11th July 2023

Development Application DA2022/1985
Issues response/ addendum Statement of Environmental Effects
Demolition works and construction of a residential flat building
27 Wayne Street, Freshwater

Figure 1 - Plan extract showing sightlines from Wayne Street to the south of the site.

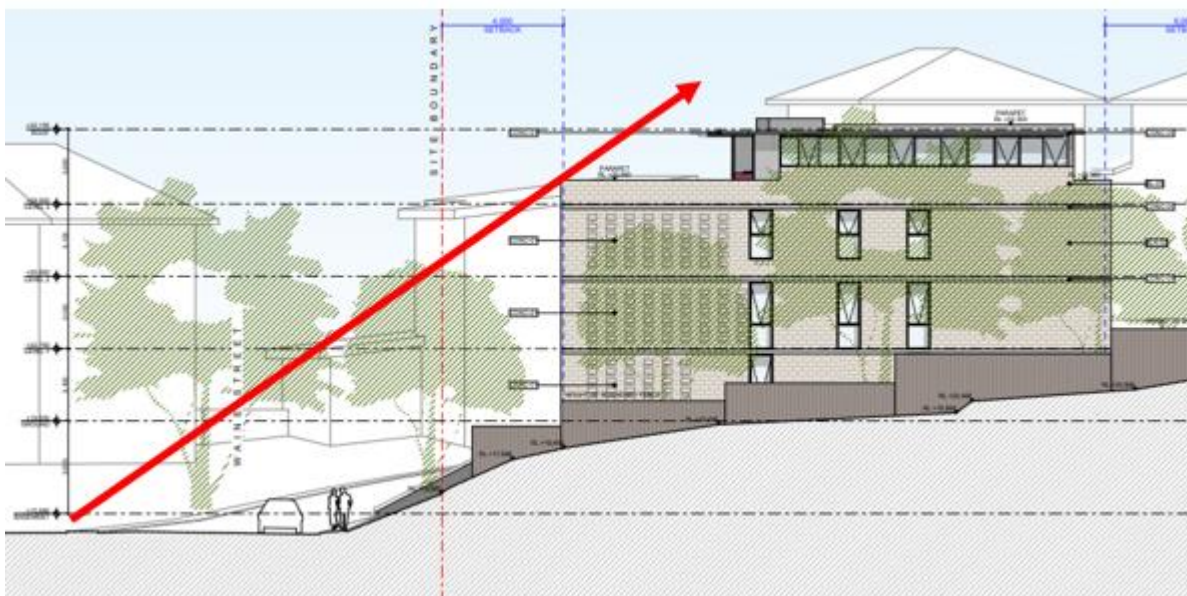
1. Building height

Response: The reduction in dwelling yield and the provision of single level floor plates has facilitated a reduction in overall building height and associated massing along the southern edge of the development consistent with the outcome required by Council and DSAP. The image over page demonstrates that the upper level will not be readily discernible as viewed from the south of the site with the southern façade of the development as viewed from the south fully compliant with the building height standard.

Response: The image at Figure 1 above demonstrates that whilst non-compliant with the storeys control that the building presents as a predominantly 3 storey stepped building form as viewed from Wayne Street given the unique topographic characteristics of the site relative to the levels established along Wayne Street and its location on a bend in the road. The upper level is a recessive element of the building both in terms of setbacks and the use of lightweight materials. We rely on the clause 4.6 variation request to demonstrate that the height of the development is acceptable have regard to the consistency of the proposed building height with that established by development within the site's visual catchment.

Figure 1: Height blanket diagram

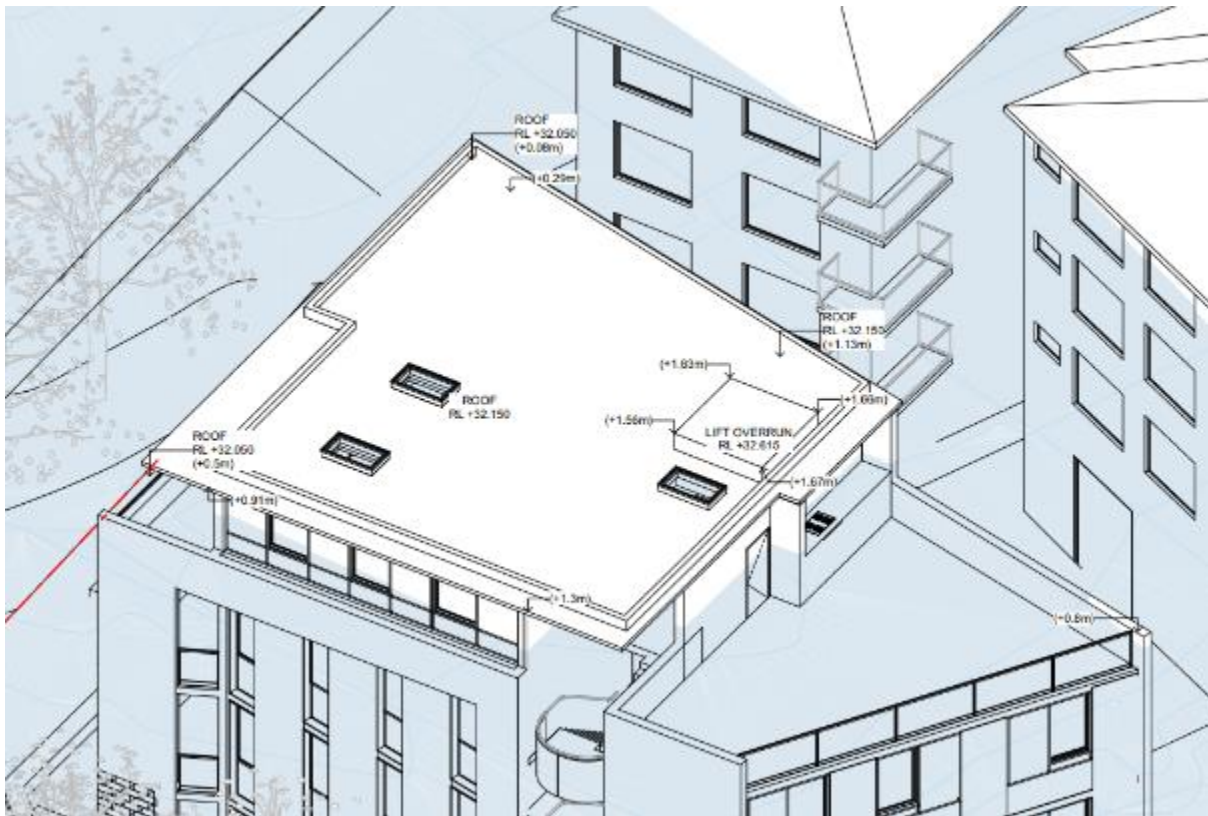
The upper level of the development breaches the building height standard by a variable degree as nominated on the building height blanket plan extract at Figure 1 over page. proposed development reaches a maximum height of 12.67m, representative of a 1.67m or a 15% variation of the 11m building height development standard. The extent of non-compliance is depicted in the Height Plane Diagram in Figure 1. In this regard, the north-eastern corner of the roof form breaches the height standard by 0.08mm (0.7%), the north-western corner of the roof form breaches the height standard by 500mm (4.5%), the south-western corner of the roof form breaches the height standard by 1.3 metres (11.8%) and the south-eastern corner of the roof form breaches the height standard by 1.13 metres (10.2%).

The lift overrun breaches the height standard by a maximum of 1.67 metres or 15%.

Response: The maximum non-compliance, being 1.67m, occurs at the south-western corner of the proposed lift overrun. The non-compliance associated with the primary roof form, ranges across the site up to a maximum of 1.3m, with the areas of greater non-compliance generally located centrally on the site.
